Agenda Item # 2 - HOLDOVER SUB-003594-2025

The Cottages at Spring Hill Subdivision

- Subdivision approval to create six (6) legal lots of record from one (1) existing legal lot of record.

DETAIL SITE PLAN

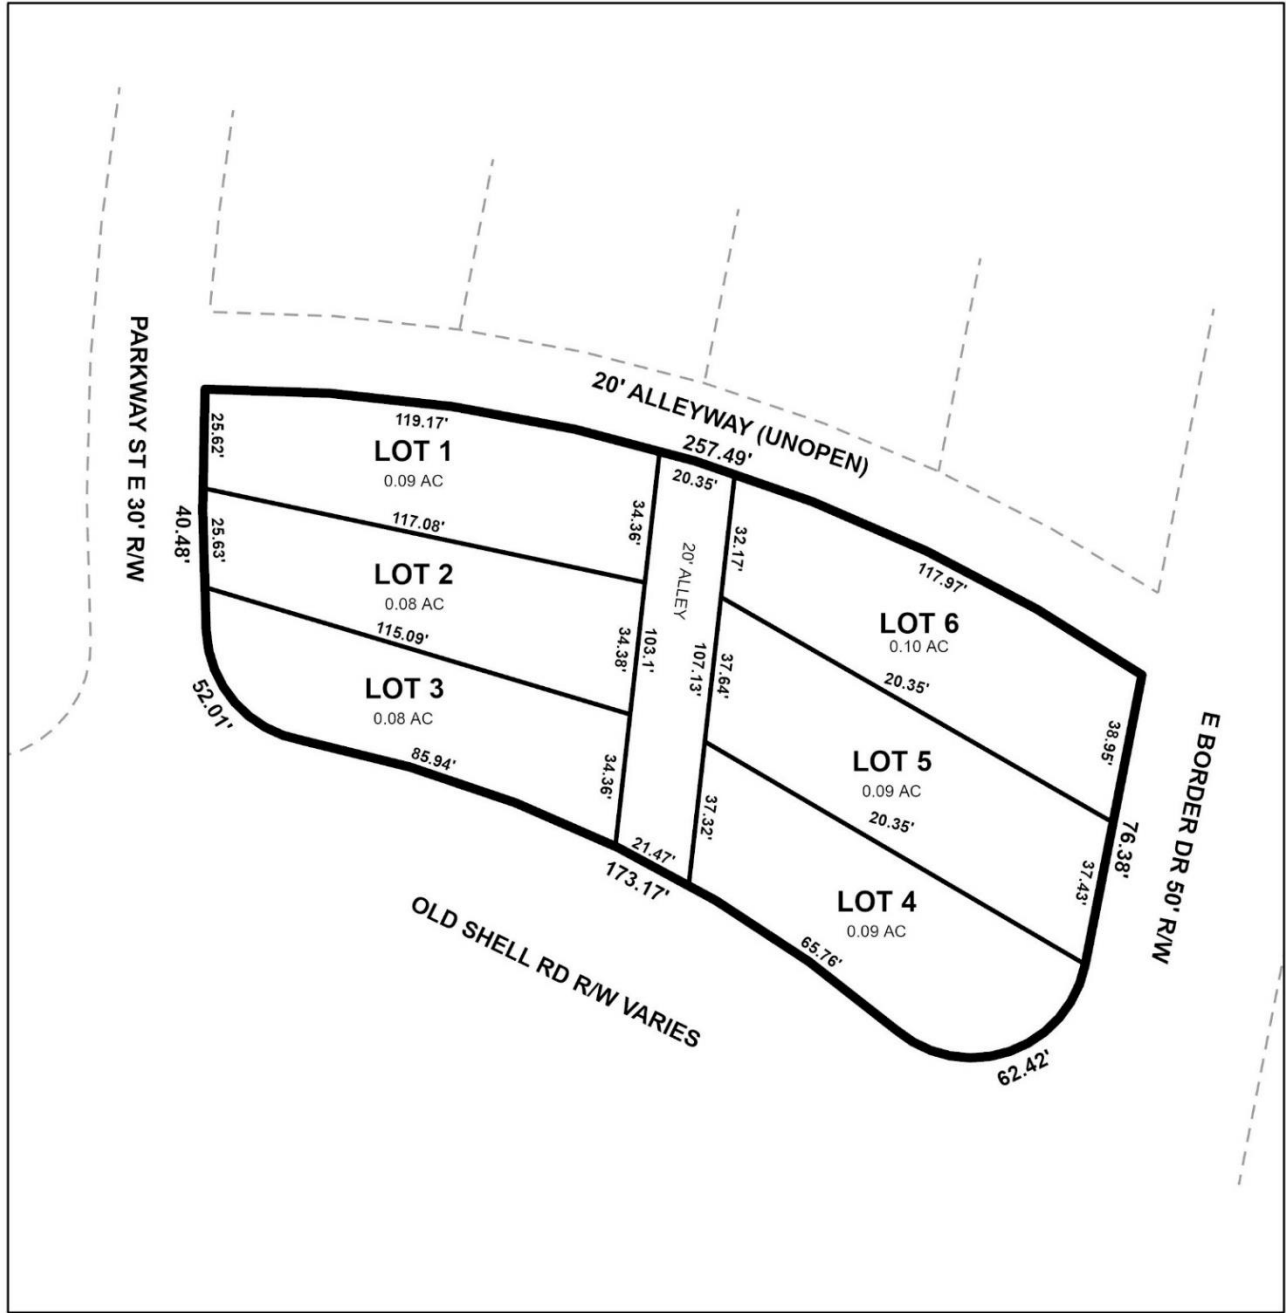
- B. Check the proposed Subdivision Name. The application indicates SPRING HILL COTTAGES, and the drawing indicates COTTAGES AT SPRING HILL.
- C. The PLAT submitted is listed as SHEET NO 1 of 2. Provide a copy of SHEET 2 for review.

- D. The area labeled 20' ALLEY must be relabeled as a COMMON AREA or ACCESS EASEMENT.
- E. SURVEY NOTES #2 - correct the address in - from "...570..." to "...5070..."

The site has frontage along Old Shell Road, Parkway Street East, East Border Drive, and an alley. Old Shell Road is a minor arterial street in this area and, as such, should have a right-of-way width of 60 feet. It should be noted that the preliminary plat depicts the right-of-way as varying; therefore, if approved, the Final Plat should be revised to clearly depict that a minimum of 30 feet exists between the subject site and the centerline of Old Shell Road.

Parkway Street East is a minor street without curb and gutter and, as such, should have a right-of-way width of 60 feet. The preliminary plat submitted depicts the existing right-of-way as being 30 feet; therefore, dedication to provide 30 feet from the centerline of Parkway Street East should be required, if approved.

East Border Drive is a minor street without curb and gutter and, as such, should have a right-of-way width of 60 feet. The preliminary plat submitted depicts the existing right-of-way as being 50 feet; therefore, dedication to provide 30 feet from the centerline of East Border Drive should be required, if approved.

The alley has an existing, compliant 20-foot-wide right-of-way, which should be retained on the Final Plat, if approved. It should be noted that the SHO requires lots less than 65 feet in width to have a rear alley. Each of the proposed lots is less than 65 feet in width, and a new 20-foot-wide alley is proposed between the lots, thus complying with this requirement.

The 25-foot maximum building setback line is not depicted along any of the street frontages. If approved, it should be depicted along all street frontages, adjusted for dedication. The 25-foot maximum building setback line is not required to be illustrated along the alleys.

It should be noted that the SHO allows for no required side yard setback and a five-foot (5') minimum rear yard setback. To reduce confusion, it is recommended that the side yard setbacks be removed from the "Site Data Table", if approved.

1. Revision of the plat to depict that a minimum of 30 feet exists between the subject site and the centerline of Old Shell Road;
2. Dedication to provide 30 feet from the centerline of Parkway Street East;

3. Dedication to provide 30 feet from the centerline of East Border Drive;
4. Illustration of the 25-foot maximum building setback line along all street frontages on the Final Plat, excluding the alleys, as measured from any required right-of-way dedication;

7. Revision of the plat to remove setbacks from the "Site Data Table";
8. Placement of a note stating that no structures exceeding three (3) stories tall may be constructed;
